MONTGOMERY COUNTY HISTORIC PRESERVATION COMMISSION
STAFF REPORT

Address:	9 West Lenox Street, Chevy Chase	Meeting Date:	2/13/2008
Resource:	Contributing Resource Chevy Chase Village Historic District	Report Date:	2/6/2008
Applicant:	Stephen & Ellen Conley (Donald Lococo, Architect)	Public Notice:	1/30/2008
Review:	HAWP	Tax Credit:	None
Case Number:	35/13-08D	Staff:	Josh Silver
PROPOSAL:	Rear addition, patio installation

SUBJECT: 9 West Lenox Street, Chevy Chase (Chevy Chase Village Historic District)

SITE PLAN

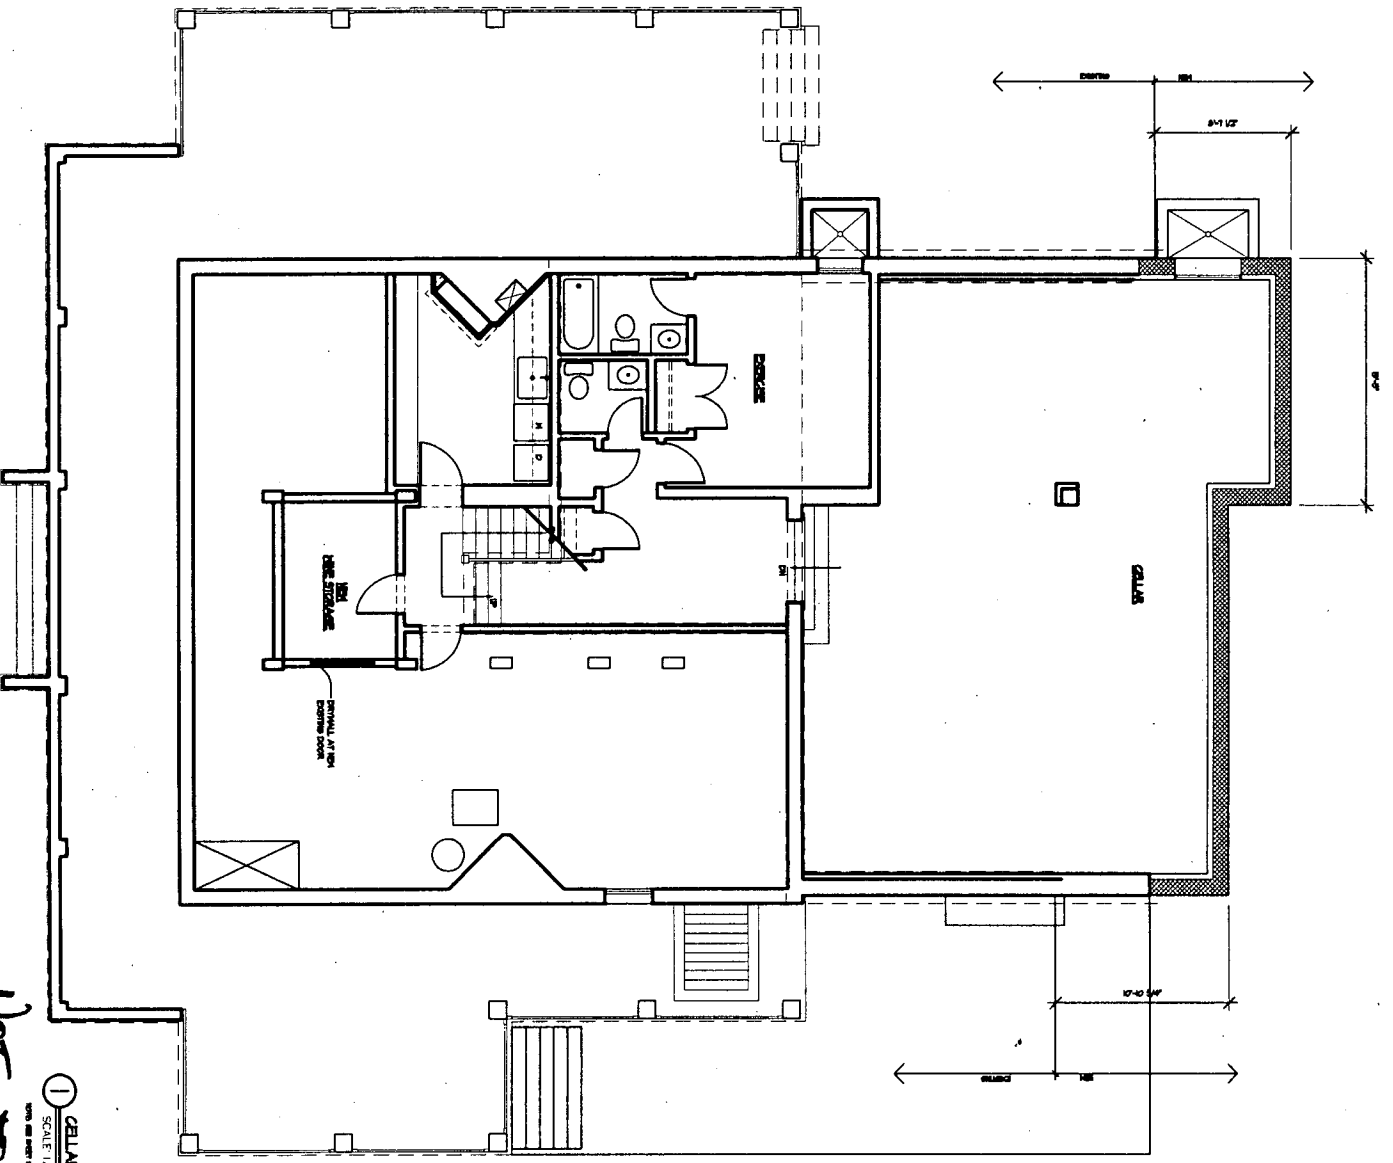
Please find attached a corrected staff report for Case IV-D, 9 West Lenox Street, Chevy Chase. The site plan initially submitted with the HAWP application for the project shows a new one-story addition only. It was brought to attention that the applicants are proposing a one-story addition which also includes a minor expansion of the existing second story addition at the rear of the house. The attached staff report has been corrected to include this revision. Please remove pages 1-4 from your staff report for this case. The applicants and LAP have also been sent a corrected version.

1 CELLAR - FOUNDATION PLAN
 SCALE: 1/8" = 1'-0"
 HPC SEE SHEET 02 FOR OPERATIONAL NOTE & DETAILS
 1/8"

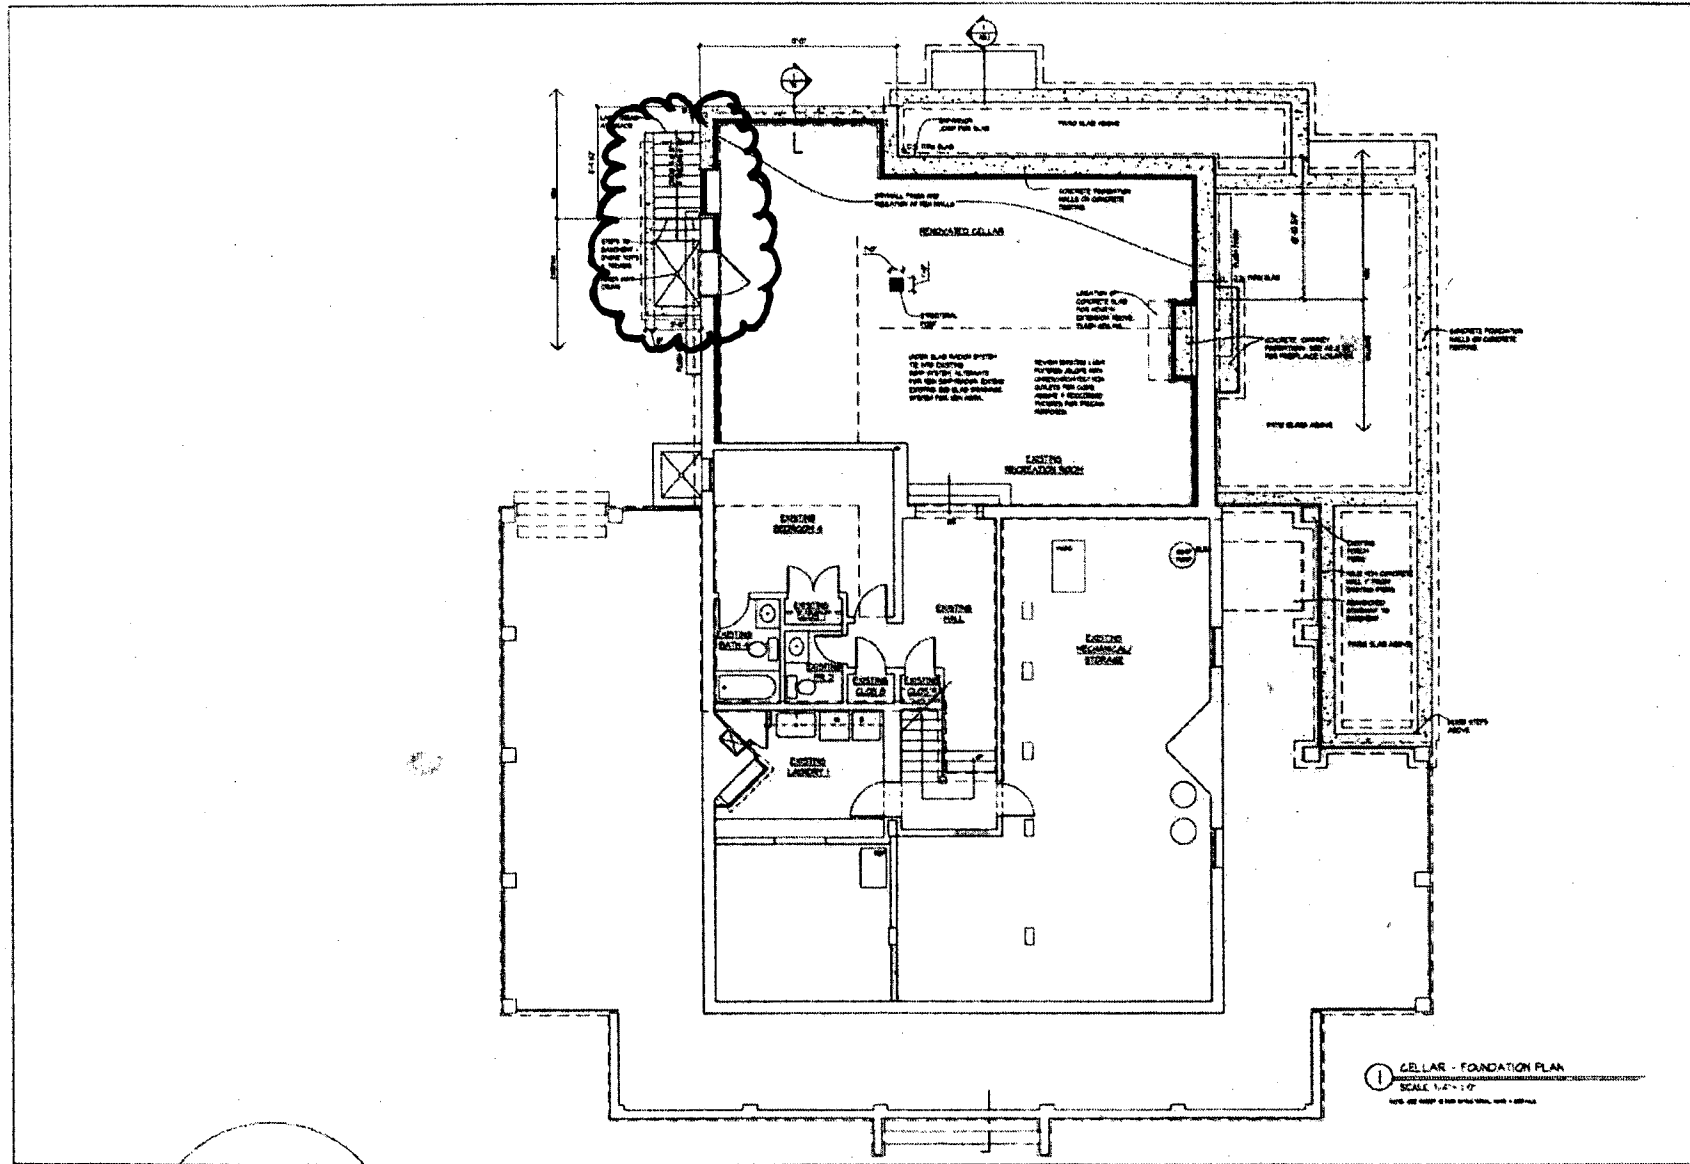
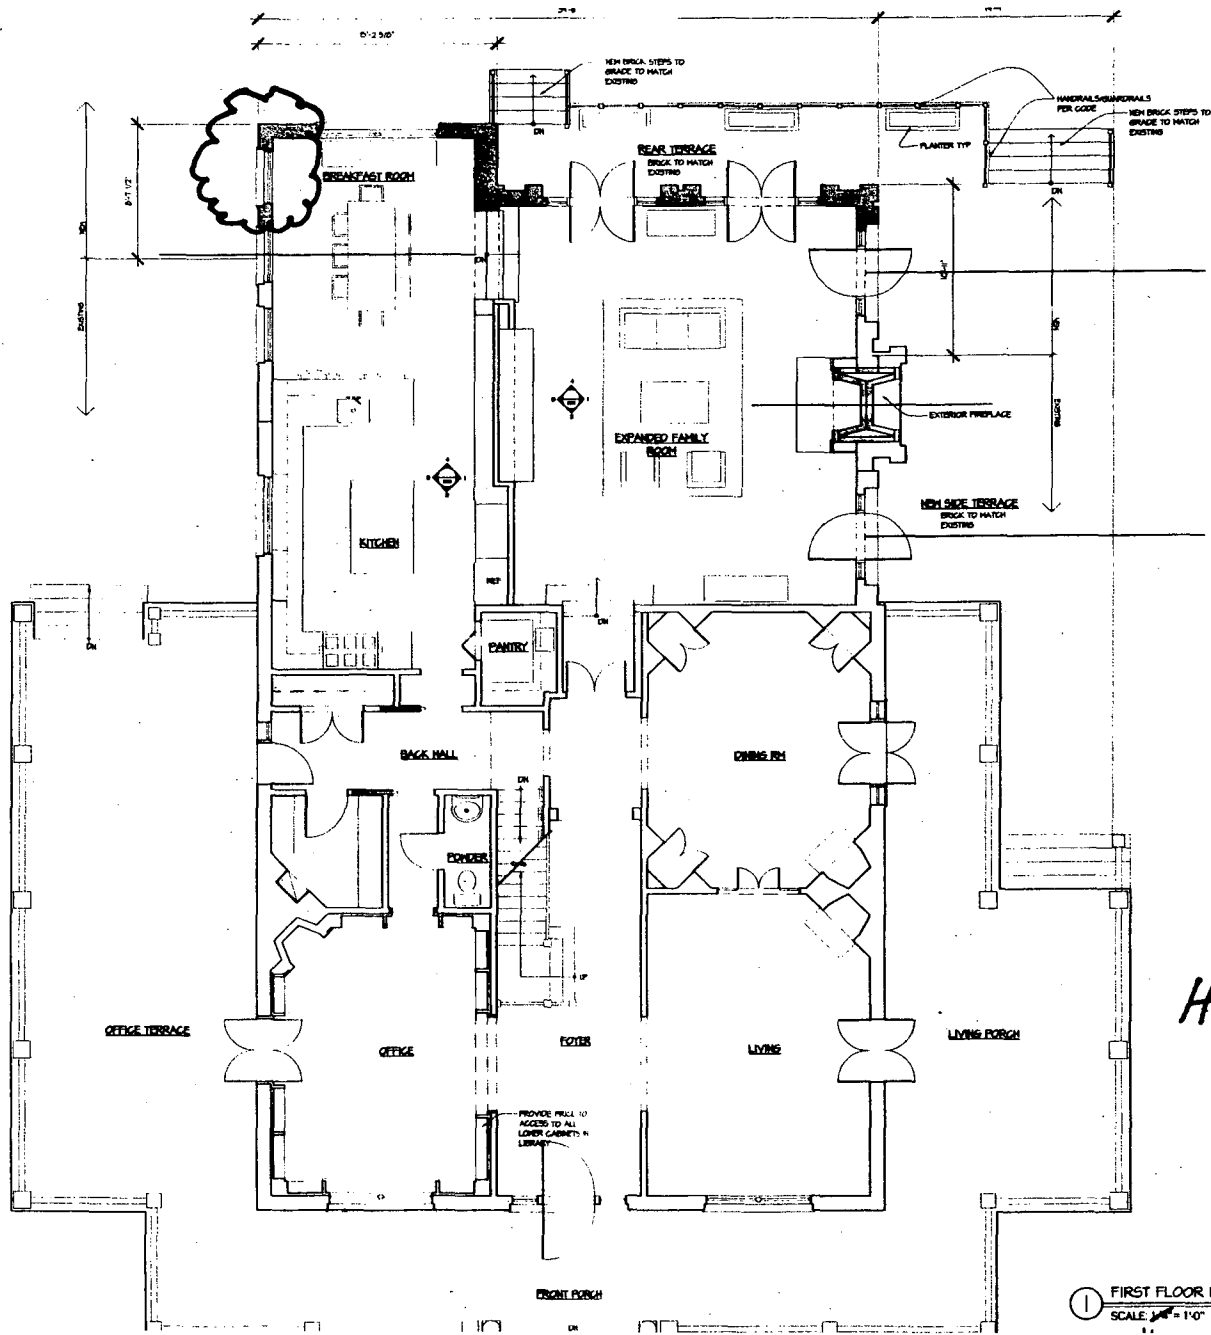
PROPOSAL: The applicants are proposing to install a new areaway and basement level entry door on the left elevation of the house. The new areaway and entry door will be located toward the rear of the house and connect to a c.1990 addition and the HPC approved rear addition. All materials for the proposed areaway will match the existing brick areaways on the house.

STAFF RECOMMENDATION: Staff is recommending the HPC allow staff level approval for the proposed changes.

HPC DECISION: APPROVE
